**Re - Submission to Further Information Request  
Croskell PSP - 585 Berwick - Cranbourne Road, Clyde North  
Planning Application**

To	<b>Victorian Planning Authority</b>	From	<b>Nina Barich</b>
Copy	<b>Galileo Clyde North Nominee Pty Ltd atf Galileo Clyde North Trust, C/- KLM Spatial</b>	Reference	<b>2402</b>
Date	<b>25 November 2024</b>	Pages (including this page)	<b>9</b>
Subject	<b>585 Berwick Cranbourne Road, Clyde North Functional Design – Without Prejudice</b>

Figure 4.1 – WLRB4 Asset with 2.44 ha Drainage Reserve

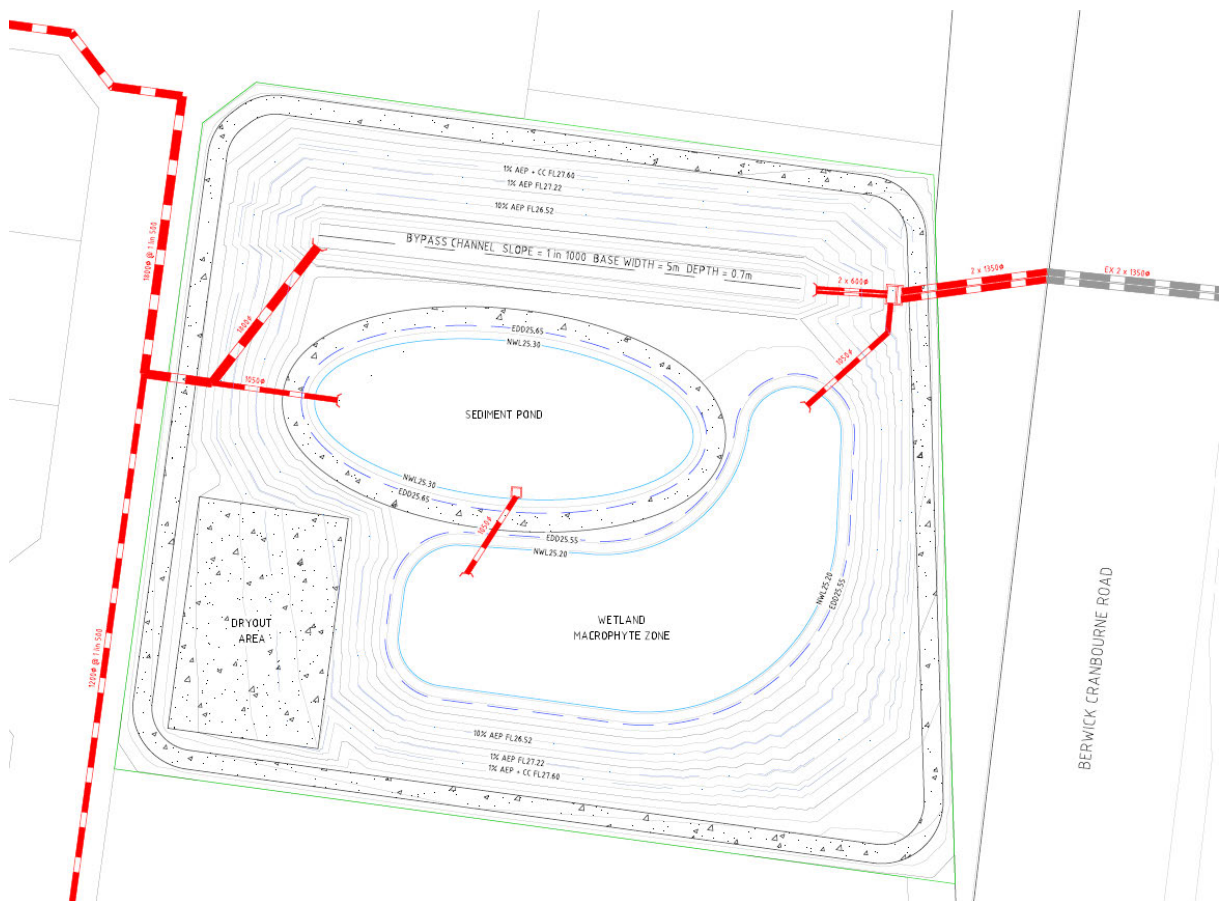
- Outfall culverts: Refer to the functional design plans.
- Sections through WLRB4: Refer to the functional design plans, design is / can be compliant with Melbourne Water guidelines.

- Land-take ensures design safety and maintainability: Refer to the functional design plans. Batters do not exceed 1 in 5, access is provided, dryout area meets Melbourne Water requirements.

To accommodate the retardation and treatment requirements stated above, as well as comply with Melbourne Water's requirements for constructed wetlands, a drainage reserve of 2.44 ha has been adopted for WLRB4 within the site at 585 Berwick Cranbourne Road, Clyde North.

The design has given consideration to the connection to the existing culvert crossing and has adopted a NWL for the sediment pond of 25.3 m AHD and a NWL for the macrophyte zone of 25.2 m AHD. A bypass channel is provided across the northern portion of the drainage reserve, sized to convey the regular design flows not entering the constructed wetland system.

The outlet pit and pipe connection will control the discharge from the drainage reserve across Berwick Cranbourne Road. The design has included paths, a dry-out area above the 10% AEP flood level, and batters not steeper than 1 V : 5 H. **Figure 4.1** illustrates the proposed design of the WLRB4 asset.
